# External Technical Review of ARROW-PAK Container

**August 2007**

## EXTERNAL TECHNICAL REVIEW TEAM

Figure 5. (a) Empty ARROW-PAK, (b) ARROW-PAK with a 55-gallon drum and corrugated spacers inside, (c) Three ARROW-PAKs banded together inside the ICV of TRUPACT-II, (d) Three ARROW-PAKs before, and (e) After loading into the ICV.

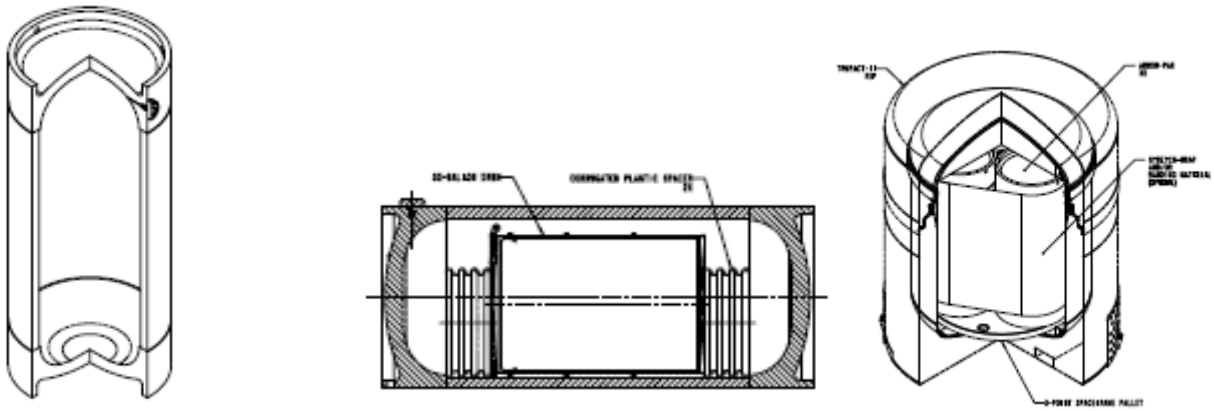
*Revise Drawing No.163-007, Rev. 1, to specify the type and capacity of the corrugated plastic spacers used to roughly center the 55-gallon drum along the length of the ARROW-PAK. This information is required to ensure that the spacers will have sufficient capacity to keep the 55-gallon drum in place roughly at the center along the length of the ARROW-PAK. Material information on the plastic corrugated spacers is required to evaluate structural performance of the TRUPACT-II package to meet 10 CFR 71.31 and 71.33 requirements.* [27]

**Team evaluation**: The applicant has not provided the type and material specification for the corrugated plastic spacers. The crush results of the prototypic specimens may not be representative of the 18-in inside diameter, 10.5-in long corrugated plastic spacers. The geometry of the spacer and its deformation may affect hydrogen deflagration inside ARROW-PAK. (See team evaluation of applicant's response plan for RAI 3-1.)

*Explain how the 55-gallon drum will remain in its position at the center during the transport and handling, when the plastic spacers are not restrained at the other end. Also, verify that the configurations for HAC tests are consistent with the configurations shown on the drawings. Information on the use of the plastic corrugated spacers is required to evaluate structural performance of the TRUPACT-II package to meet 10 CFR 71.31 and 71.33 requirements.* [27]

**Team Evaluation**: The applicant's response implies that there is a maximum axial gap of 7.5 in. between a spacer and the inside surface of the hemispherical head of the ARROW-PAK container. This gap may not have a negligible effect on the dynamic response of the container during a 30-ft end drop. Also, the 18-in inside diameter spacers and the 55-gallon drum may be off-center in the radial direction inside an ARROW-PAK container with an inner diameter of 26.5 in. The geometry of the spacer and its deformation and movement during transport and handling and HAC may affect hydrogen deflagration inside ARROW-PAK. (See team evaluation of applicant's response plan for RAI 3-1.)

**Applicant's Response**: *Drawing No.163-007 will be revised as requested to include the size (length and diameter), type, and capacity of the corrugated plastic spacers. Of note, Section D-D of drawing sheet 3 does not currently depict the spacers at their correct, as-tested length of 10.5 inches each. That view will be redrawn to scale and dimensions provided. In addition, as a part of our response to this RAI, a representative spacer will be axially crushed solid, and the resultant force deflection curve provided.* [28]

**Applicant's Response**: *A discussion of the location of the 55-gallon drum during NCT and HAC will be provided as requested. The maximum amount of axial free play between drums, spacers, and the ARROW-PAK heads will be quantified and the significance of that free play on normal and accident conditions will be discussed. Given the response to RAI 1-1, it will become clear that the maximum possible axial offset of a drum from being centered in an ARROW-PAK is approximately 3.5 inches, which will have a negligible affect on package response.* [28]
